**AGENDA
TECHNICAL REVIEW COMMITTEE (TRC)
June 2, 2026
10:00AM**

**Re: Variance Request for Dumpster Pad & Front Parcel Entrance
SWC-23 American Auto RV & Boat Storage
City of Fruitland Park, FL
Langan Project No.: 342011215**

**DEVELOPMENT REVIEW LETTER
SWC-23 American Auto RV & Boat Storage
Major Site Plan, Variance, Unity of Title
March 9, 2026**

**Re: Major Site Plan Submittal
SWC-23 RV and Boat Storage
Langan Project No.: 342011215**

OVERALL SITE PLAN

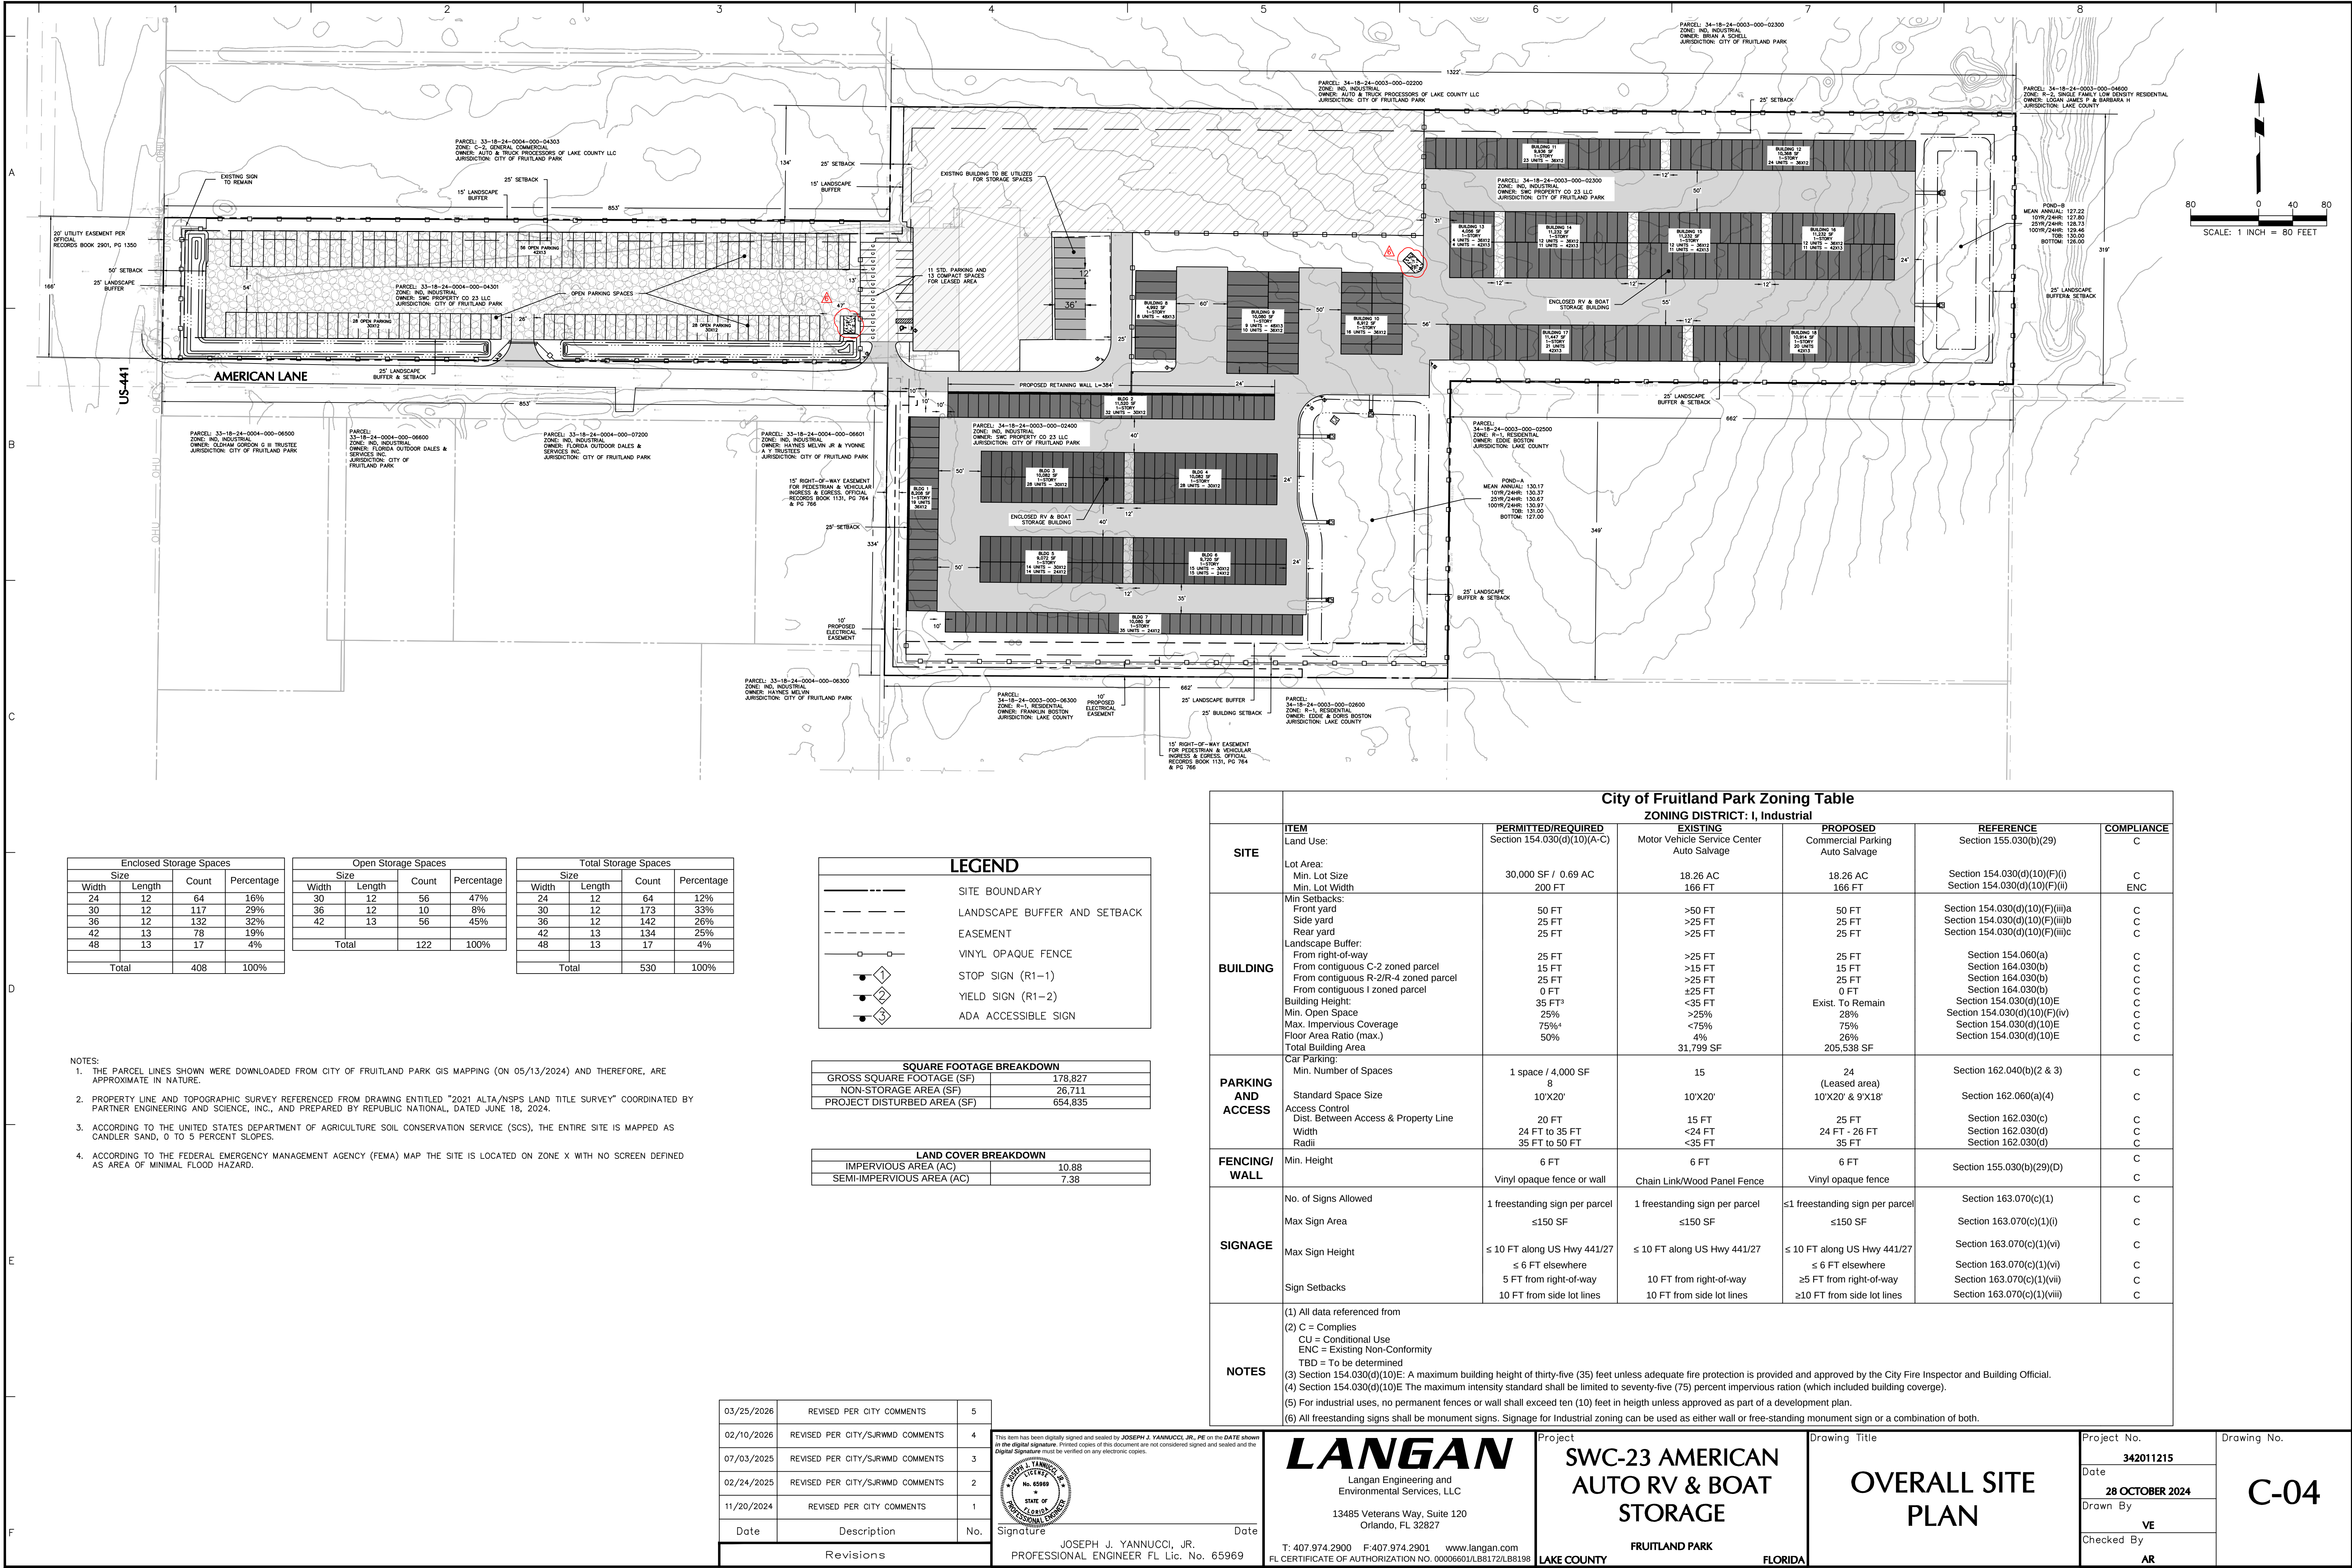
The revised plans also indicate that a variance to Chapter 159, Section 159.100(3) which requires 1 dumpster pad for every 30,000 SF of warehouse space. Sheet C-04 indicates that the proposed warehouse space is 178,827 SF which would require 6 dumpster pads. The plans indicate 1 dumpster pad.

Please revise site plan to remove the stormwater pond outside of the required 25’ buffer. Please revise the landscape plans to comply with the landscaping code of a Type C buffer.

Page C-06 does show a dumpster enclosure between buildings 10 and 13 but it doesn't seem to meet that standard detail for the city please insert attached city detail G-14 and make sure design meets these standards.

3. Page C-06 does show a dumpster enclosure between buildings 10 and 13 but it doesn't seem to meet that standard detail for the city please insert attached city detail G-14 and make sure design meets these standards.

1. Please ensure our truck can clear the corner of the building approaching the concrete pad for the dumpster and that the building has no overhang, etc. that will impede our approach. Have the pad poured as at least a 12'x12' concrete pad to allow for extra room for the dumpster and with growth potential in case an enclosure ends up being built around it later down the road.

2. The enclosures should be 12'x12' with the interior clearance being 12' and not the exterior dimensions. The doors for the enclosure should swing to a full 180 degrees and not stop at 90 degrees. They should have drop pins and holes drilled to secure the pins in the closed and open position for the doors. The main thing to consider here is ensuring the hinges are installed on the posts so they allow the doors to open and do not become trapped on the posts so to speak. If curbing is being installed to the side of the enclosure, just ensure the opening on the bottom of the door will clear it when opening the door. The caveat would be if a 2nd dumpster is desired for trash or even recycle, that the enclosure is built 24' wide instead.

Response: The dumpster enclosure located between Buildings 10 and 13 has been revised to comply with City Detail G-14. In addition, a second dumpster enclosure has been incorporated within the west parcel, which has also been designed in accordance with this standard. The applicable detail has been added to Sheet C-18. Refer to the Overall Site Plan (Sheet C-04) and Partial Site Plans (Sheets C-05 and C-06) for updated layout and locations.

Response: The concrete pad dimensions in the plans have been revised to 13'-6"x20'-6" per City Detail G-14. The Pavement and Turning Movement Plan sheet (C-15A) has been revised to show that sufficient room to clear surroundings has been provided at both dumpster enclosure locations.

Response: The dumpster enclosures have been revised to match City Detail G-14. The applicable detail has been added to Sheet C-18. Refer to the Overall Site Plan (Sheet C-04) and Partial Site Plans (Sheets C-05 and C-06) for updated layout and locations.

Response: The Fruitland Park Code of Ordinances requires a 25-foot-wide landscape strip with 5 canopy trees, 4 understory trees, and 30 shrubs per 100 linear feet, but it does not prohibit the area from being used for stormwater management. The proposed on-site landscaping has been purposefully selected to be tolerant of wet conditions and to meet city requirements.
